R.F.I.

| Project Name: | Occupational Therapy/Physical Therapy Renovation | Date Requested: | 3/5/14 |
| Solicitation No.: | VA262-14-B-0366 | Reference: | Specifications |

SUSPENDED CEILING DETAIL

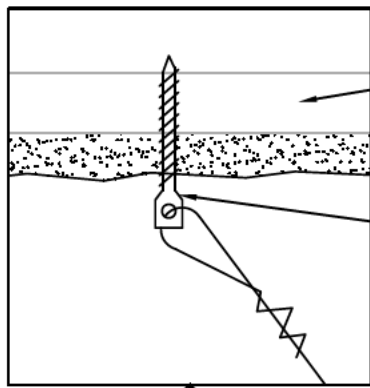
Sheet Note 7 on AE-103 calls for a portion of existing hard lid ceiling to remain in place. The RCP on AE-104 calls for new ACT which according to the Finish Schedule on AE-401 should be hung at 8'8". Should the existing ceiling remain in place? If so what is its current height? Should new ACT wires be hung from the existing ceiling?

See clarification drawing attached.

EXISTING PLASTER CEILING
FURRING CHANNEL

1/4" LONG EYE SCREW MIN.

NEW SUSPENDED ACOUSTICAL
CEILING GRID, SEE INSET DETAIL
AT LEFT FOR ANCHORAGE

EXISTING PLASTER
CEILING TO REMAIN

HANGER WIRE

DRAPERY POCKET DETAIL

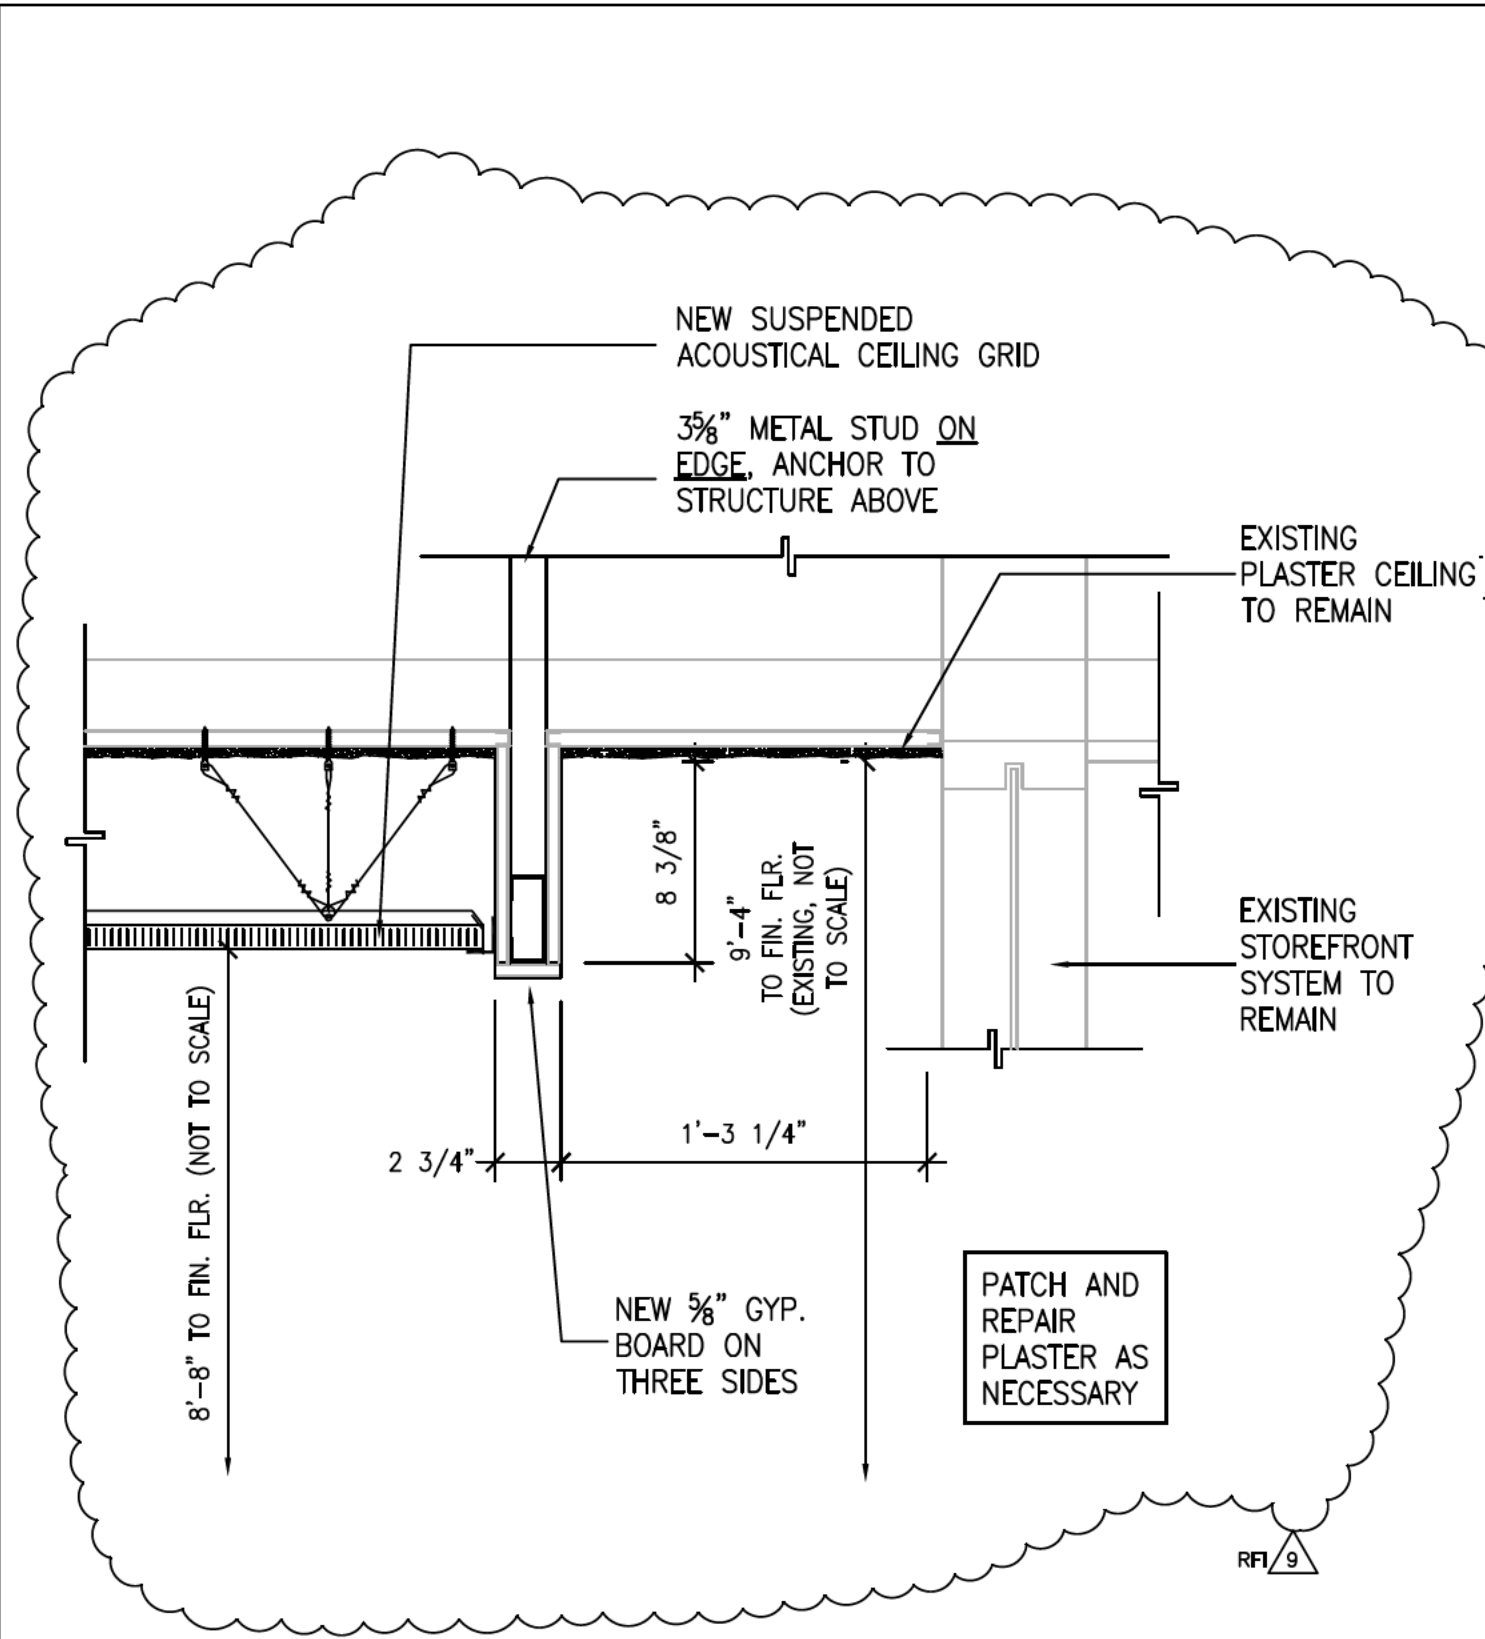
Please provide a detail for the New Curtain Pocket indicated with Sheet Note 1 on AE-104.

See clarification drawing attached.

Contractor shall provide patch and repair of existing plaster ceiling as required by modification. Refer to Specification Section 09 24 00 – Portland Cement Plastering (attached to RFI #37 Response).

REVISED SHEET AE-102

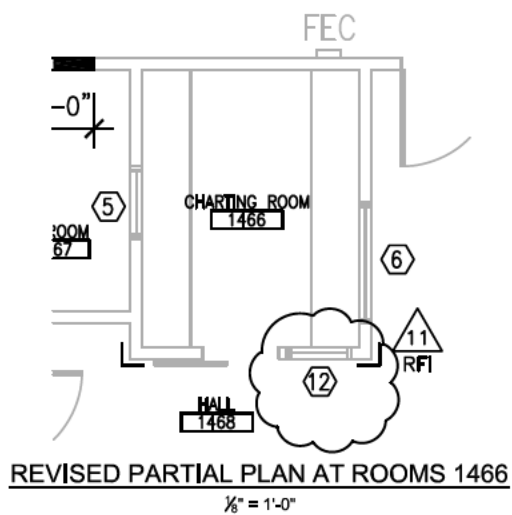
PHASE II EXISTING WINDOW BY DOOR D32 IS NOT NUMBERED IS THERE A FINISH ON THIS WINDOW?

PHASE II SHEET AE-401 INDICATES EXISTING WINDOW TO BE PAINTED (#12 ON THE WINDOW SCHEDULE) COULD YOU PLEASE CLARIFY WHERE WINDOW #12 IS LOCATED?

Window adjacent to Door D32 is Window #12 as shown on the window schedule. See clarification drawing attached.

NEW INTERIOR RAMP & LOW WALL

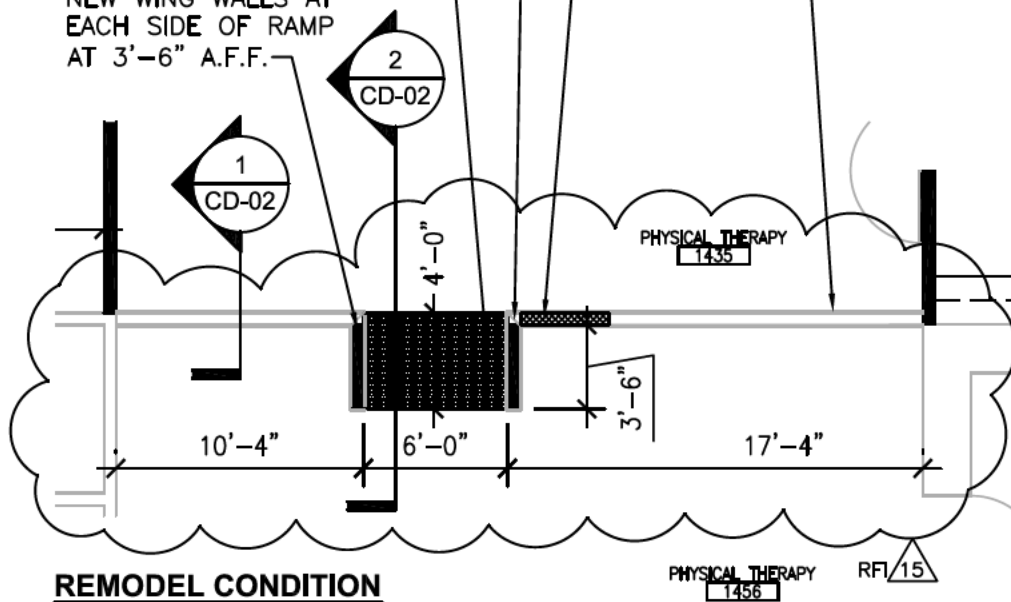
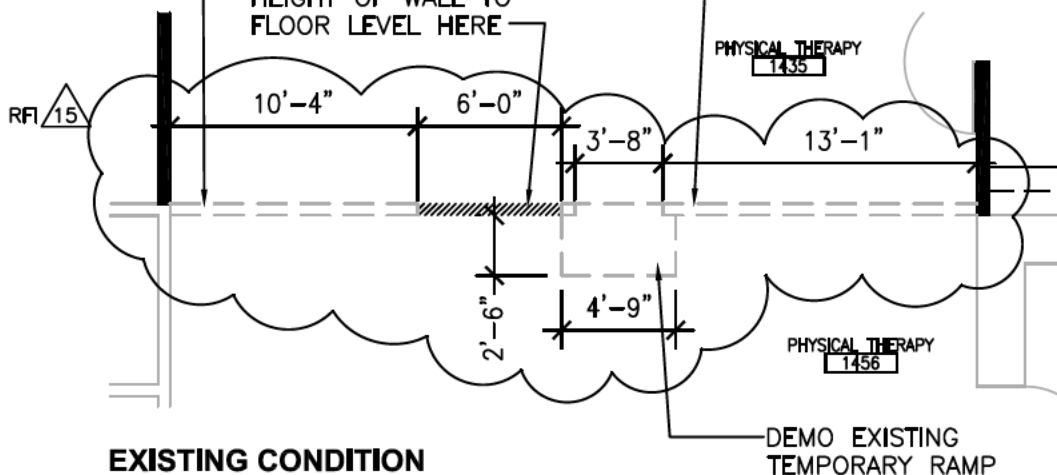
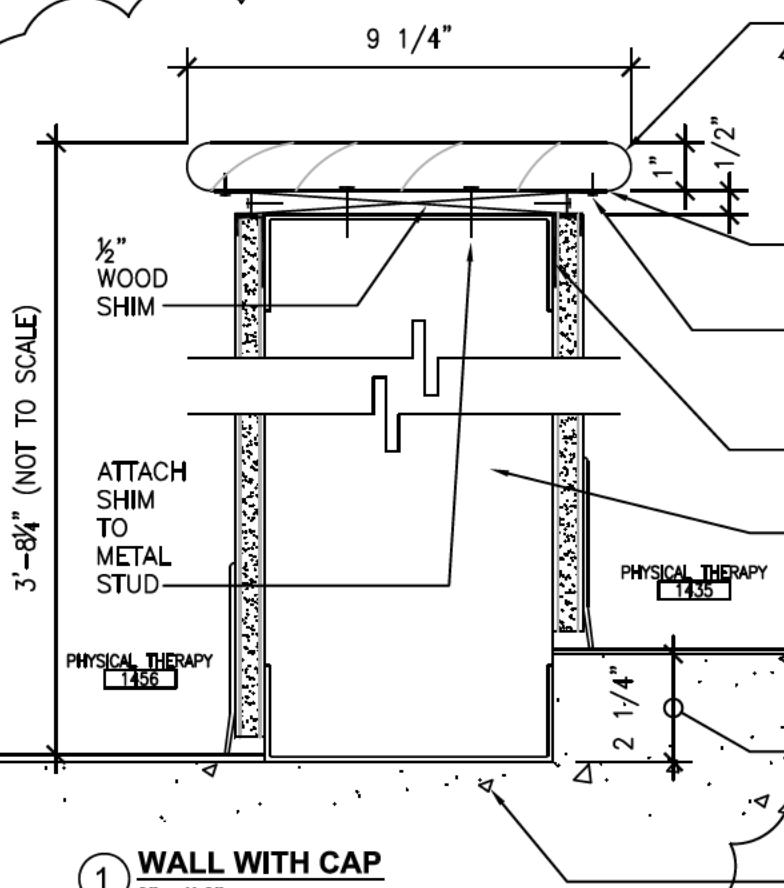
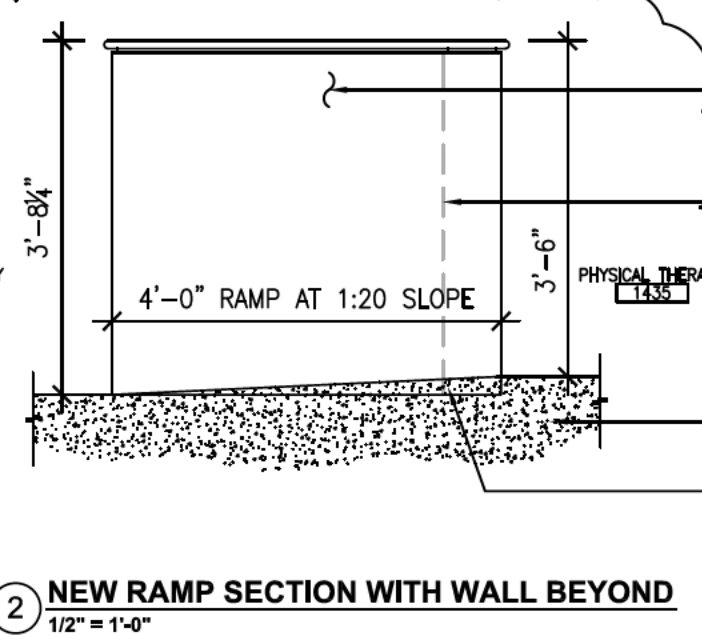
Drawing Sheet AE-101, Sheet Note #9, along Grid Line "L" refers to a wall that must remain in place until relocation takes place. The demo plan does not indicate removal of existing epoxy flooring to the north of this wall. The finish schedule indicates new vinyl sheet flooring is to be installed to the north and south of this temporary wall. At the Site Visit it was noted there is an approximately 2" to 3" finished floor height on the opposing sides of this wall. We request the VA describe the treatment required to mitigate this floor height difference.

Provide floor finishes as noted in Finish Schedule on Sheet AE-401.

Contractor shall remove existing VCT at all locations where occurs (if not previously removed by hazardous material abatement) and shall provide new finish as scheduled. At locations with existing epoxy resin floor, Contractor shall scarify and level floor as recommended by sheet vinyl flooring manufacturer and then install finish as scheduled.

INFILL EXISTING WALL OPENING TO MATCH 3'-6"
A.F.F. HEIGHT OF ADJACENT LOWERED WALL

AT 90° JUNCTION OF EACH TOP
CAP, PROVIDE 45° MITER JOINT

PROVIDE SOLID
HARDWOOD TOP CAP AT
ENTIRE LENGTH OF LOW
WALL ON BOTH SIDES OF
RAMP, FINISH WITH A
MEDIUM WALNUT STAIN

AT EXISTING WALL, DEMO ONLY
UPPER PORTION, LOWER 3'-6"
PORTION OF WALL MUST REMAIN

AT EXISTING WALL,
DEMO ENTIRE
HEIGHT OF WALL TO
FLOOR LEVEL HERE

- PROVIDE SOLID HARDWOOD TOP CAP AT ENTIRE LENGTH OF LOW WALL ON BOTH SIDES OF RAMP, FINISH WITH A MEDIUM WALNUT STAIN. PROVIDE FULL BULLNOSE AT PERIMETER EDGES.
- PROVIDE 1/2" REVEAL AT UNDERSIDE OF HARDWOOD CAP
- PROVIDE ATTACHMENT OF WOOD CAP TOP FROM UNDERNEATH WITH 5/8" WOOD SCREWS
- PROVIDE NEW J-MOLD AT TERMINATION OF GYP. BOARD.
- NEW OR EXISTING WALL, SEE CD-01 FOR EXTENT OF NEW/EXISTING LOW WALL. NEW INFILL PORTION OF WALL TO MATCH WIDTH OF EXISTING ADJACENT WALL.
- FLOOR LEVEL CHANGE THAT MUST BE ACCOMMODATED BETWEEN ROOMS 1435 AND 1456
- EXISTING CONCRETE FLOOR

- NEW WING WALL BEYOND TO MATCH ADJACENT LOW WALL HIEGHT AND FINISH
- LINE OF WALL BEYOND
- EXISTING CONCRETE FLOOR
- NEW CONCRETE SLOPED INFILL TO PROVIDE 1:20 SLOPED RAMP, FINISH CONCRETE TO RECEIVE FLOORING

SUSPENDED CEILING DETAIL

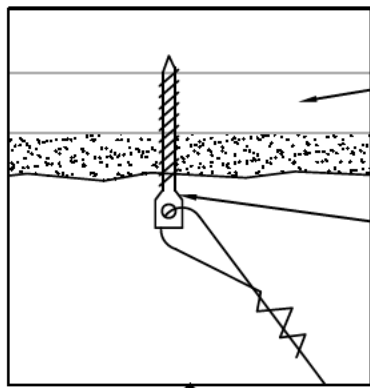
Sheet Note 7 on AE-103 calls for a portion of existing hard lid ceiling to remain in place. The RCP on AE-104 calls for new ACT which according to the Finish Schedule on AE-401 should be hung at 8'8". Should the existing ceiling remain in place? If so what is its current height? Should new ACT wires be hung from the existing ceiling?

See clarification drawing attached.

NEW SUSPENDED ACOUSTICAL
CEILING GRID, SEE INSET DETAIL
AT LEFT FOR ANCHORAGE

RFI #22

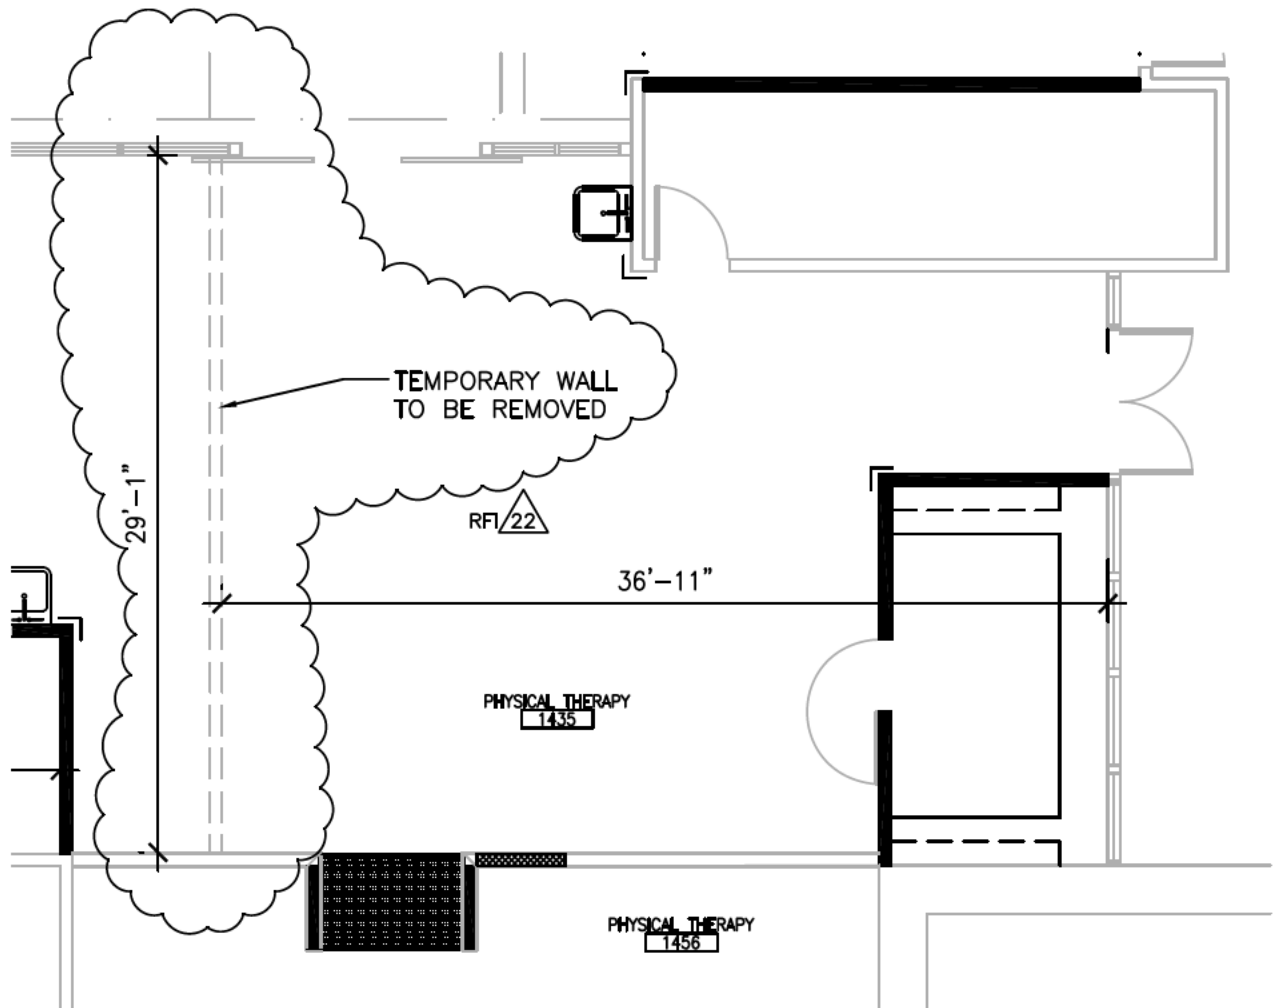
Existing/Demo Plan shows a wall to be removed at the east end of the deli/pizza equipment. It runs between gridlines 3 & 4 from L to almost L.1. During the job walk it was observed that this wall runs all the way to the glazing. Will part of this wall be removed prior to start of work? Will contractor be responsible for removing the wall as it currently stands?

See clarification drawing attached.

REVISED WINDOW TYPE "A"

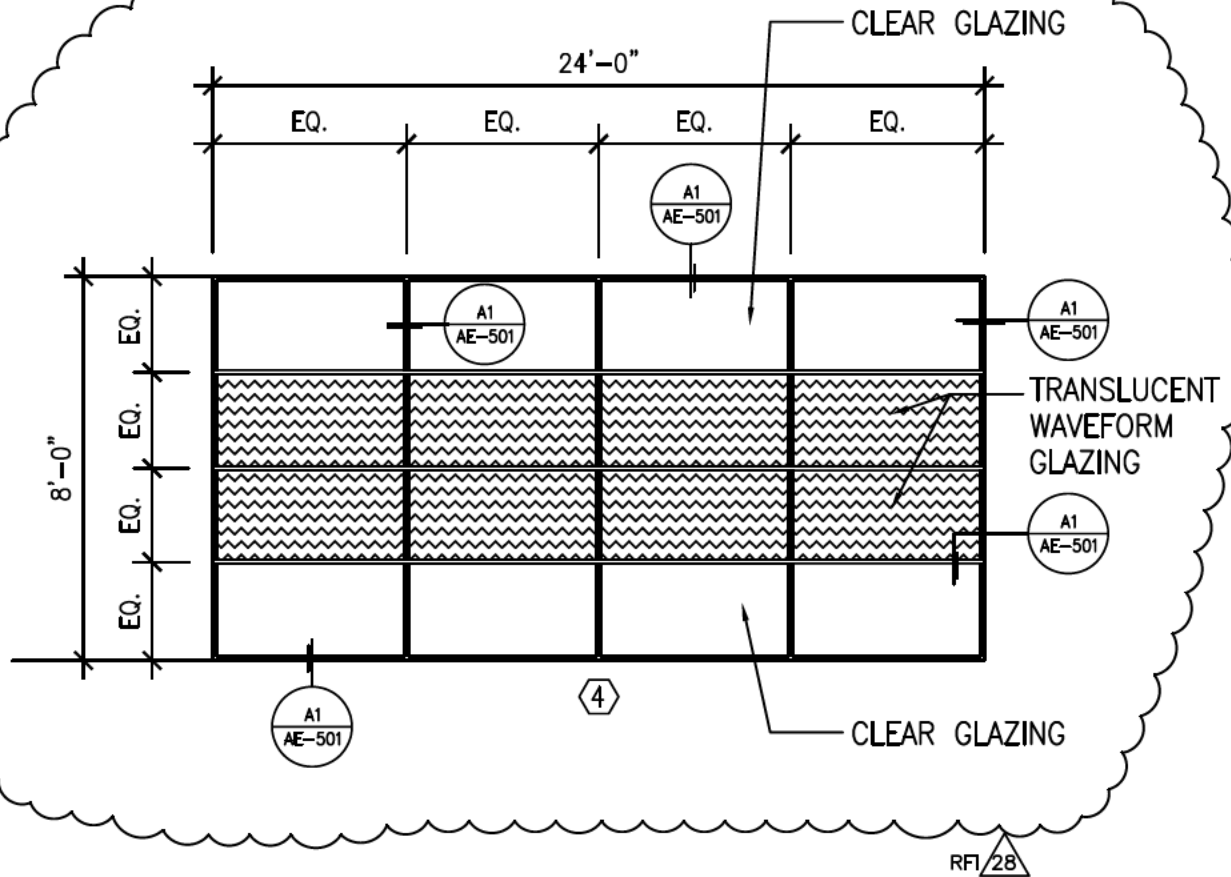
Window Type 4 is listed on the Window Schedule as 3'8" x 9'. It is shown under Window Type/Details on same page as 6' x 8'. Please clarify size of Window Type 4.

See clarification drawing attached.

REVISED SHEET AE-102

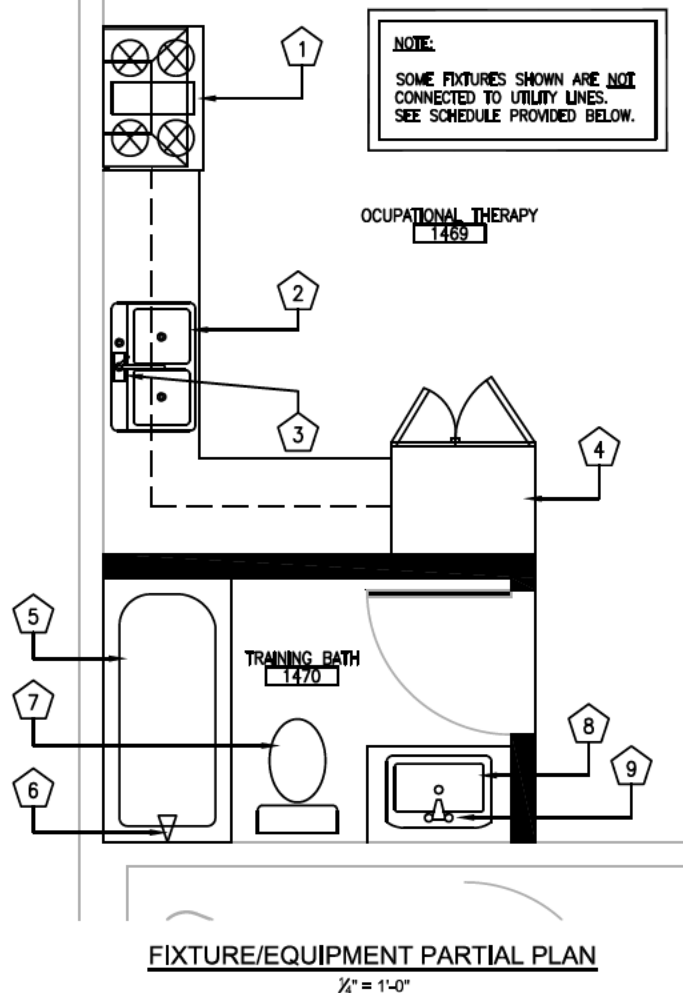
Please provide Plumbing Fixture Schedule.

See clarification drawing attached.
